Roosevelt Lofts – Historic Rehabilitation & New Apartments – 22-3281

ADDENDUM NO. 1

A DEMOLITION WEST ELEVATION
1/8"=1'-0"

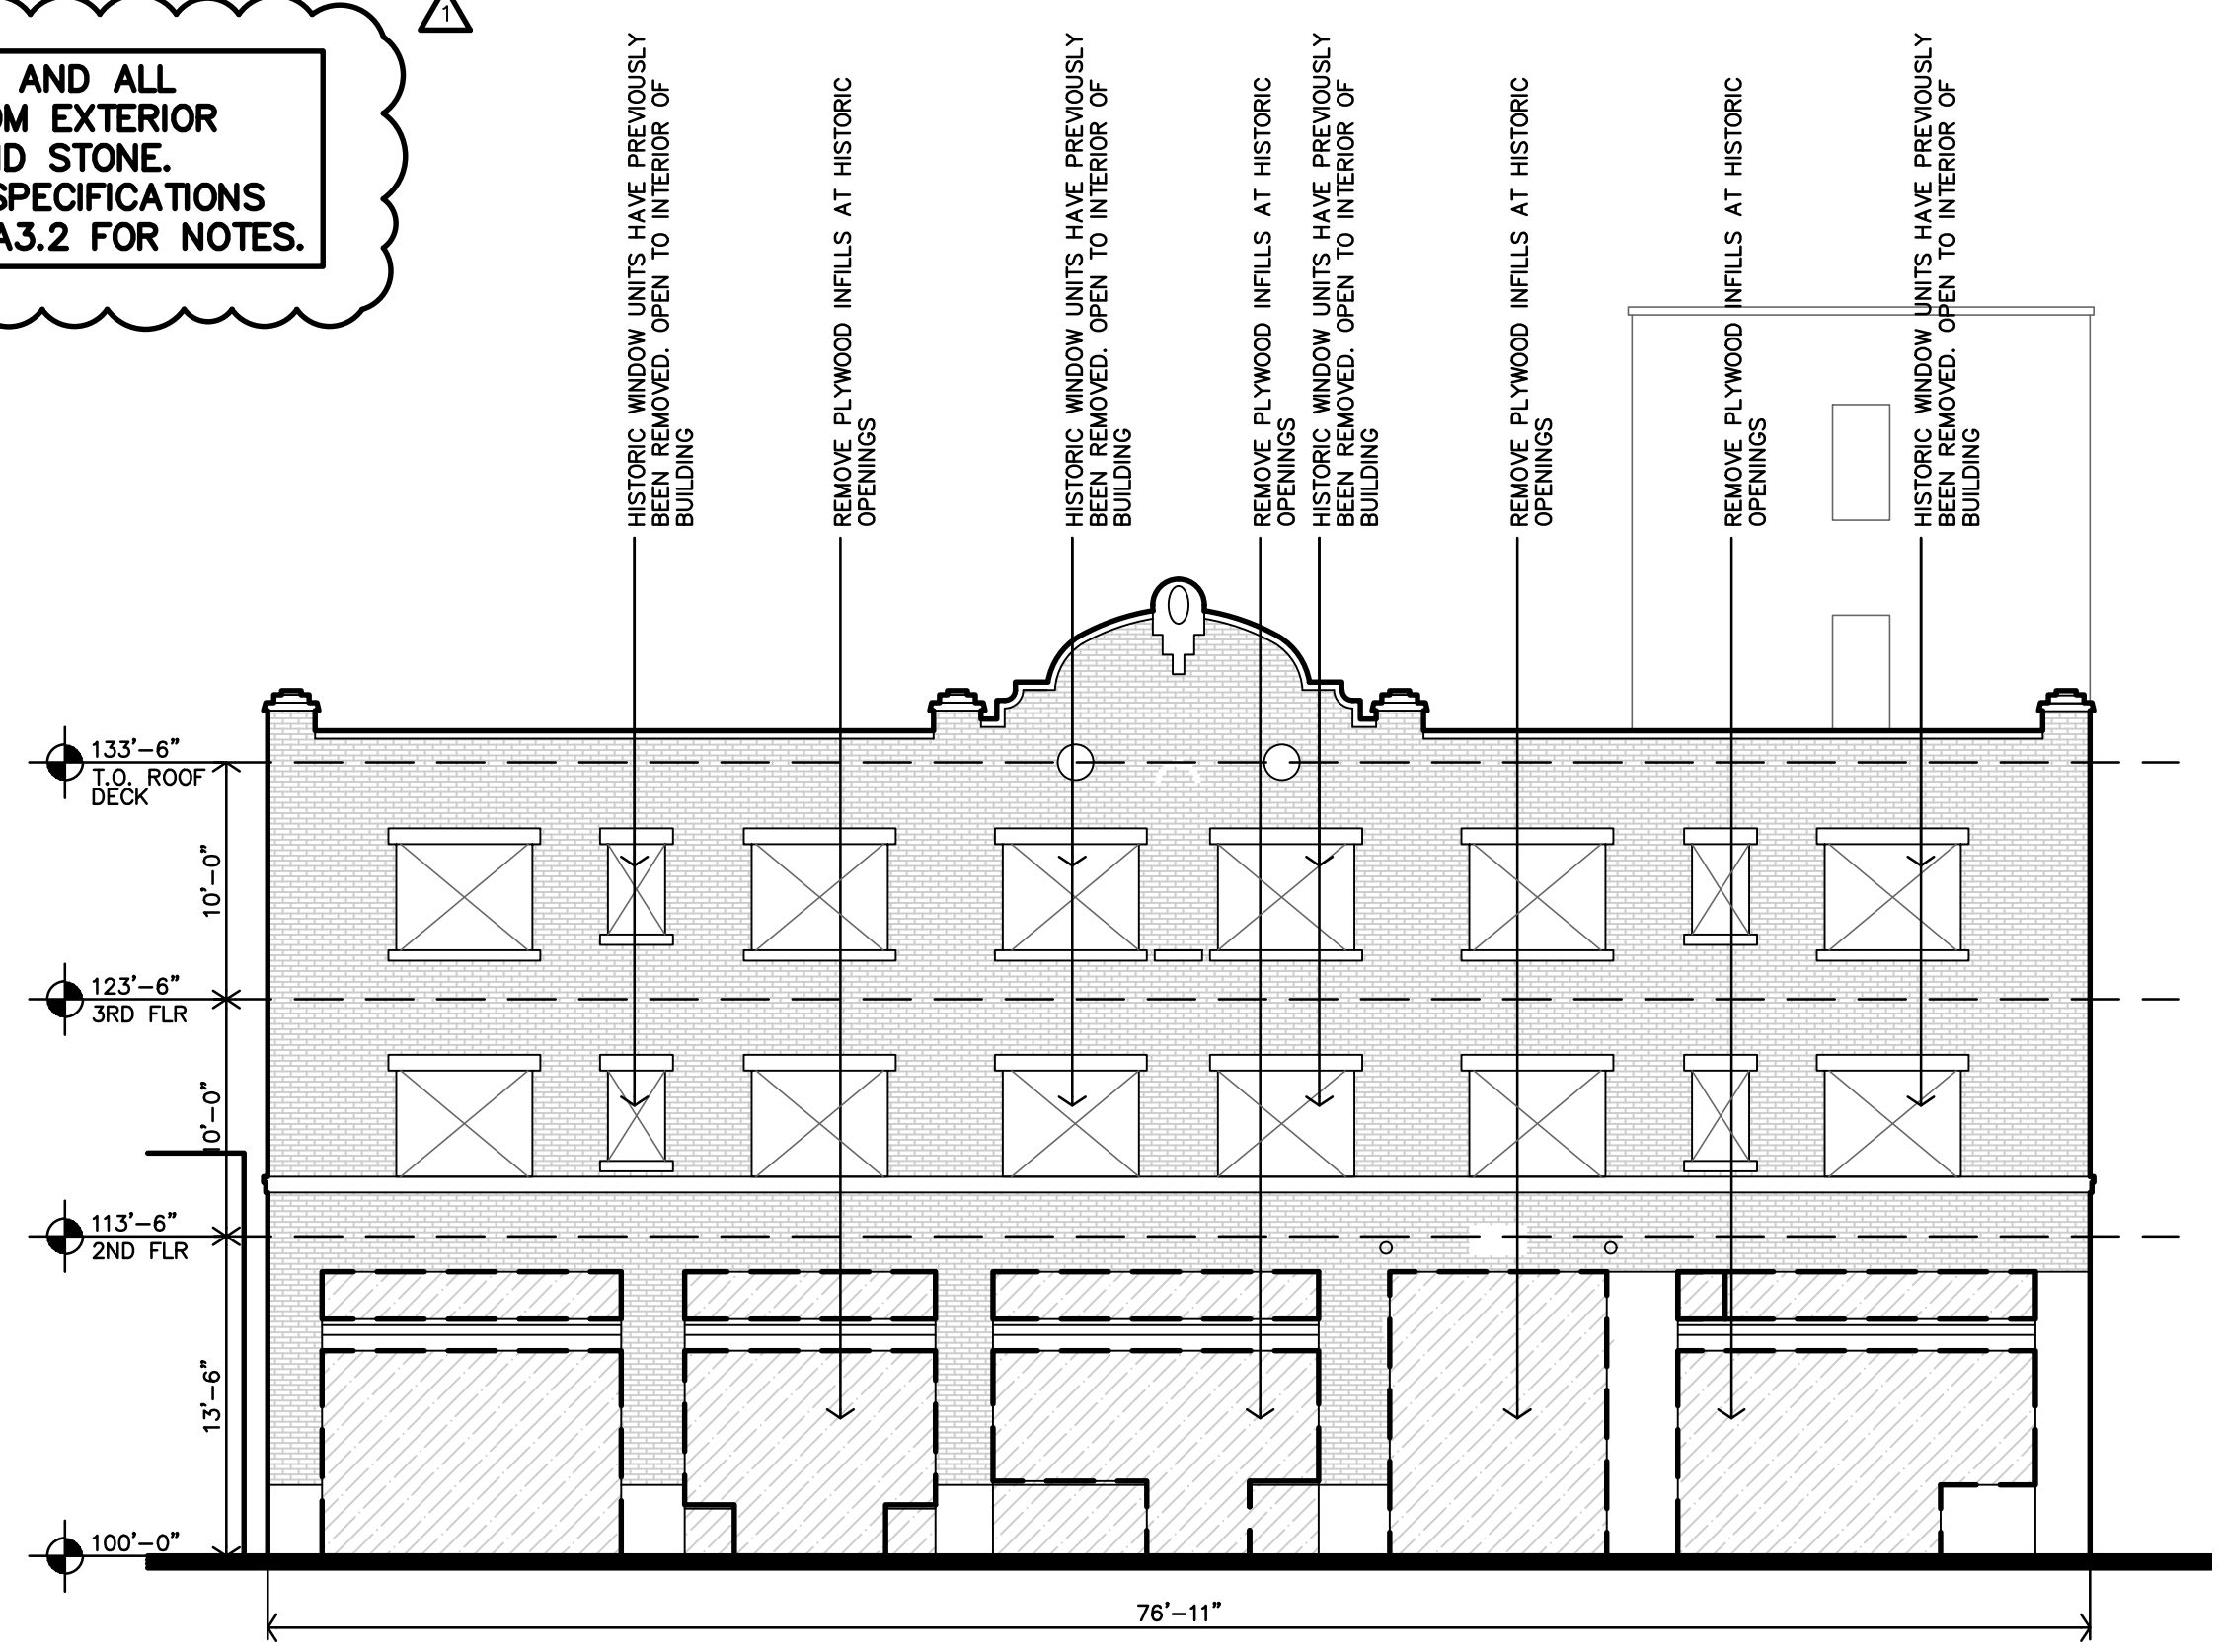
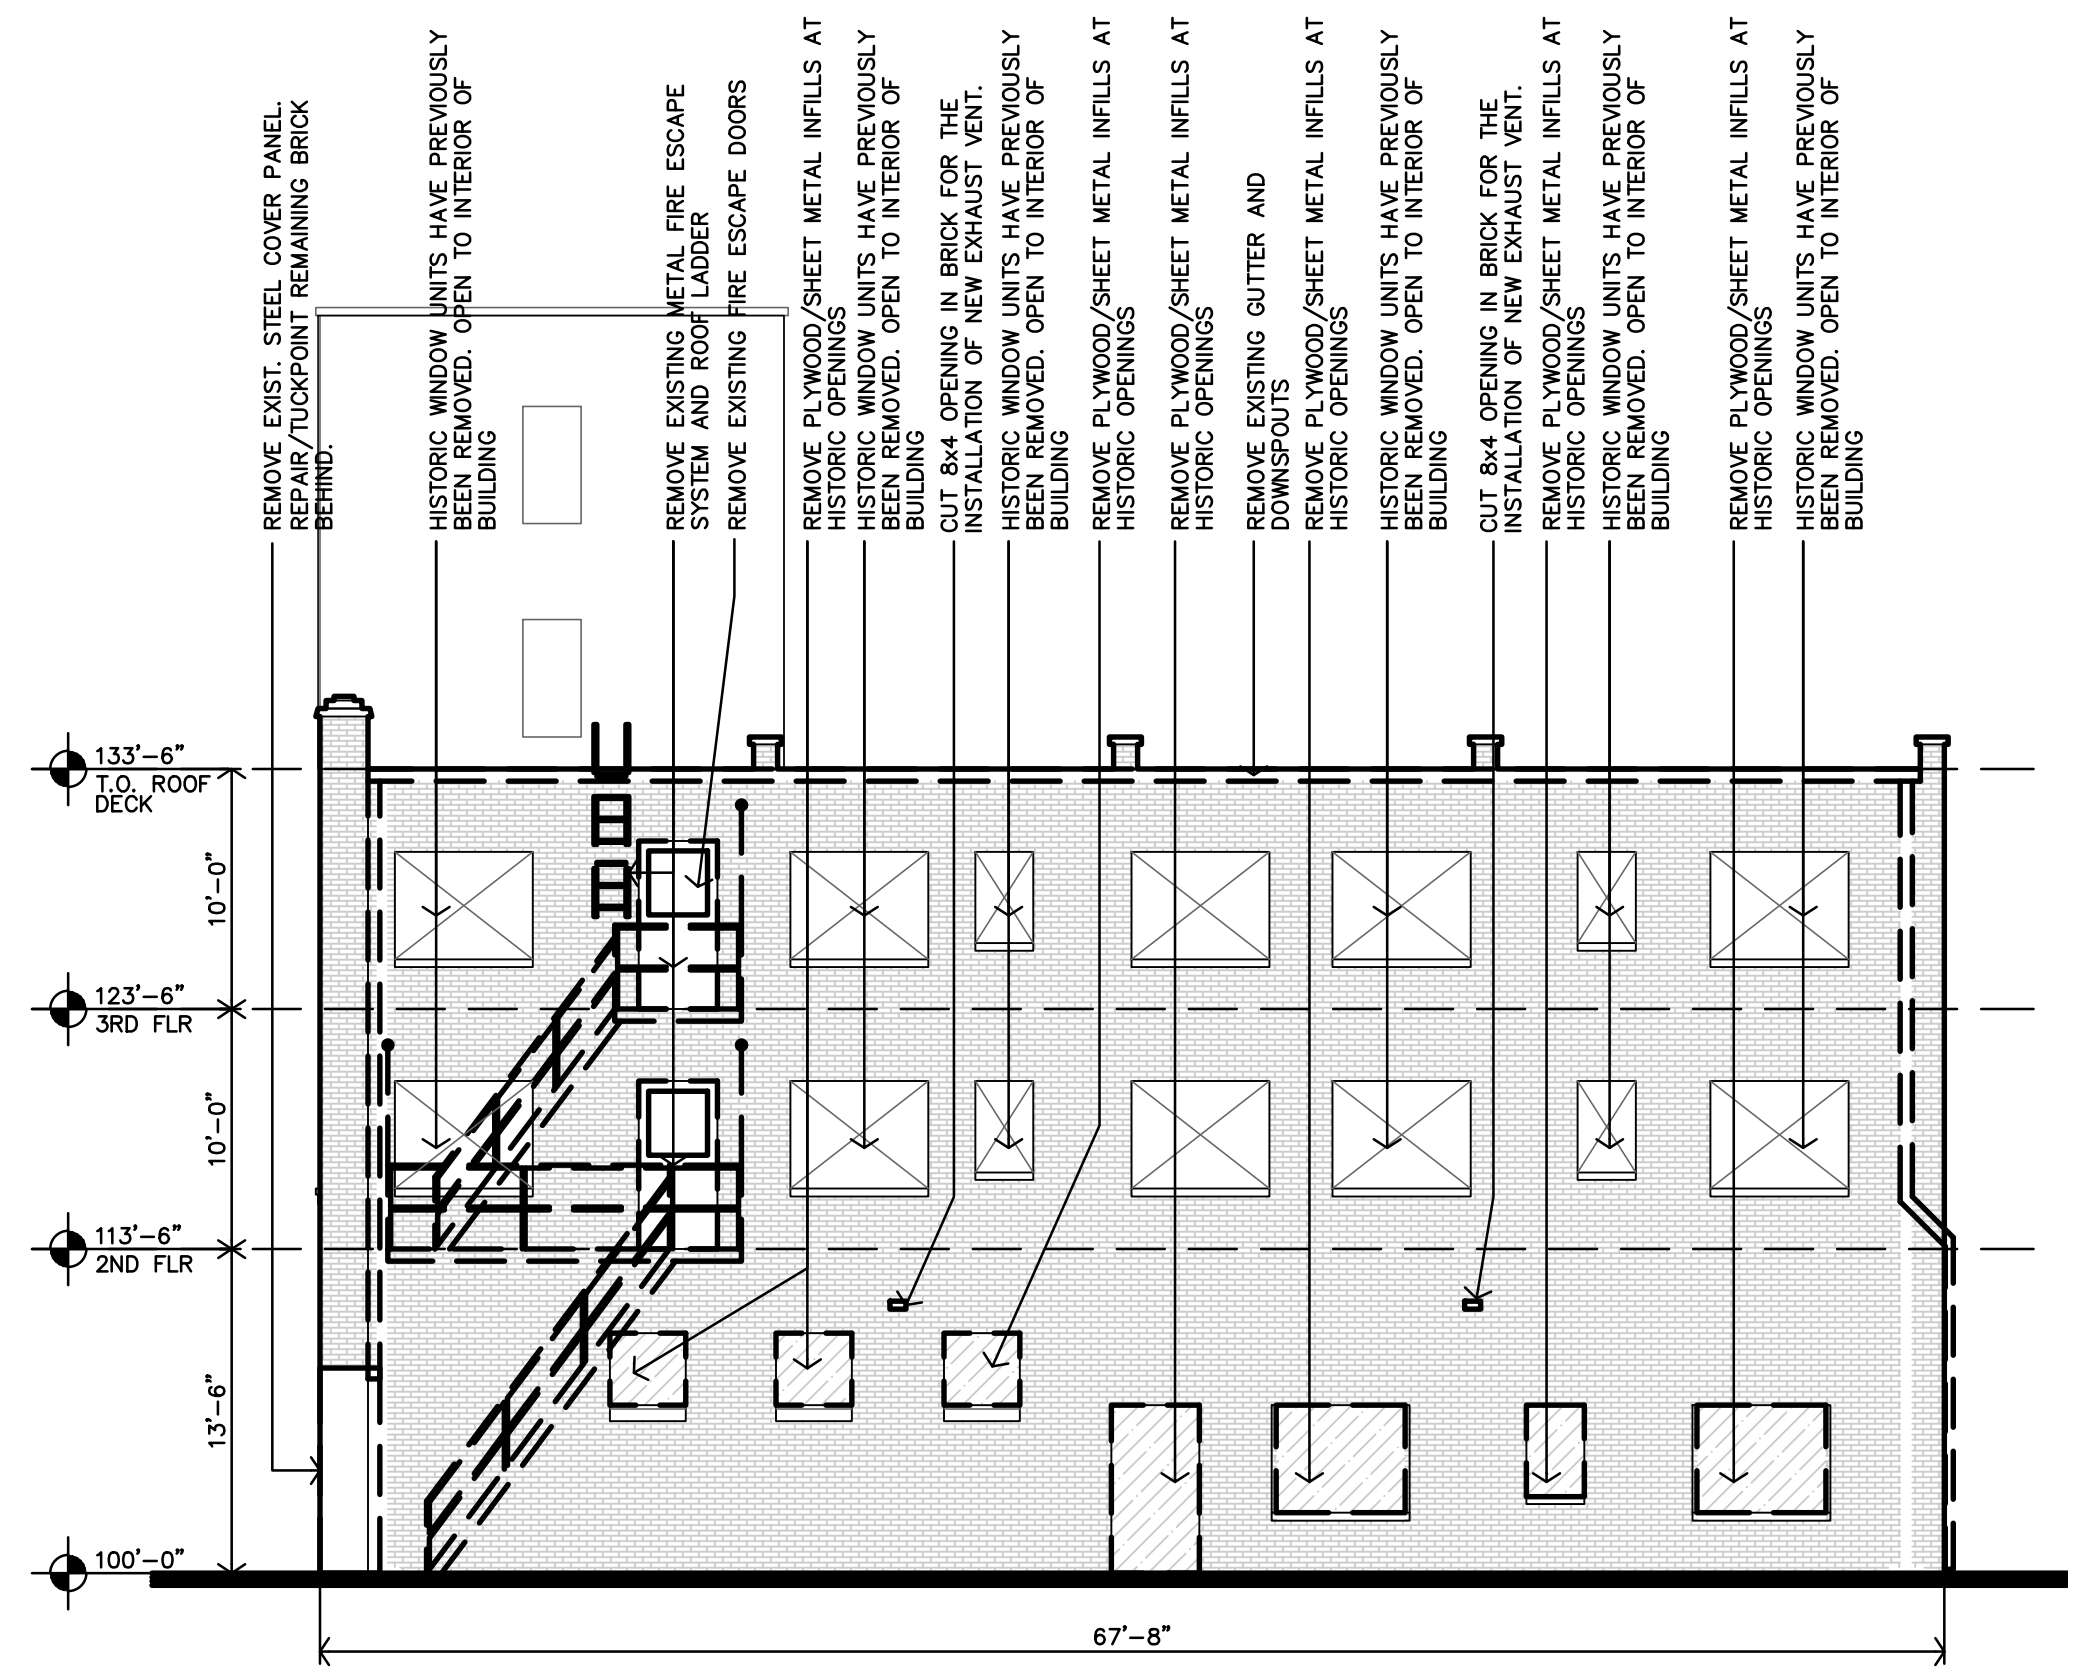
2. Sheet D3.1
 - a. Added Note to sheet: Remove any and all Graffiti from exterior masonry and stone. Reference Specifications and Sheet A3.2 for notes.

- b. Detail D – Added Note: Existing Historic painted advertisement and sign in this area. Protect during construction.
3. Sheet D3.2 – Added Note to sheet: Remove any and all Graffiti from exterior masonry and stone. Reference Specifications and Sheet A3.2 for notes.

PARTITION SCHEDULE

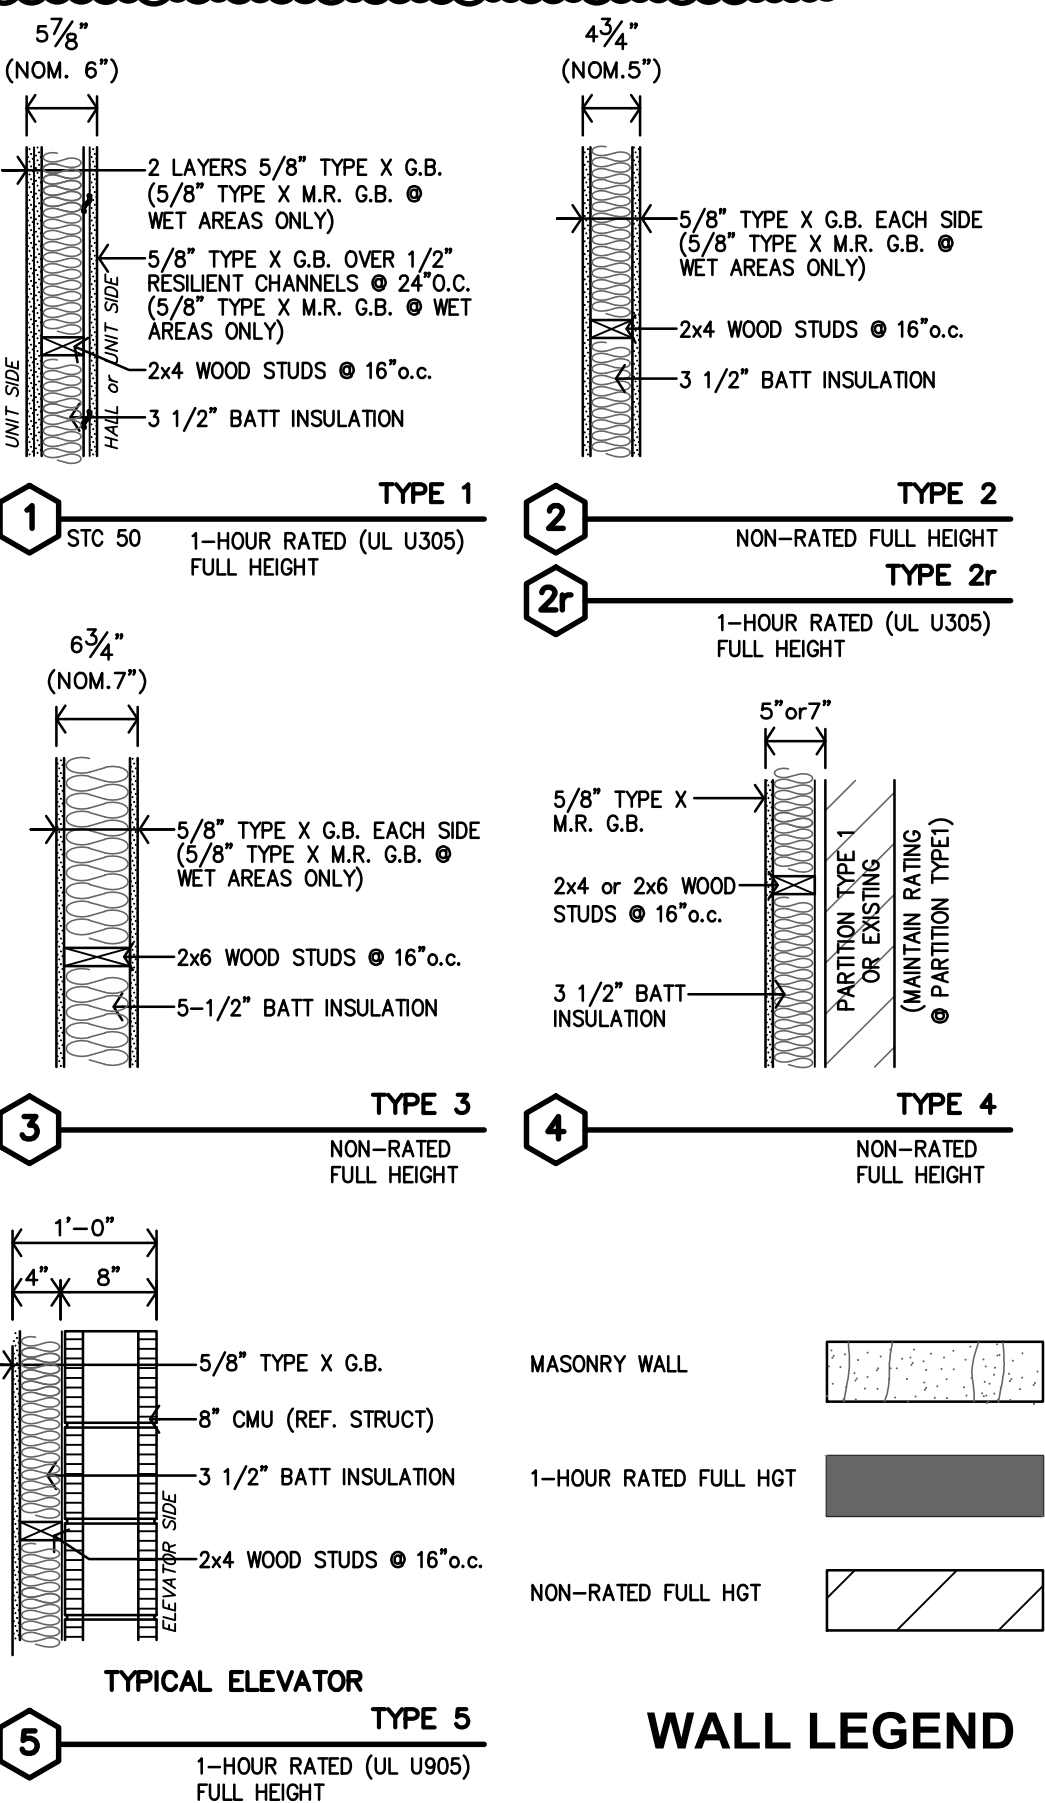
4. Sheet A2.0 – Partition Schedule:
 - a. Add note – Alternate: Install metal studs in place of wood studs. 2x4 wood studs = 3-5/8" metal studs; 2x6 wood studs = 6" metal studs.

- b. Add wall Type 1B
5. Sheets A2.3 – A2.8 – Several places where walls have been thickened to a 2x6 stud vs. a 2x4 to allow for plumbing and vent ducts to route up through them.
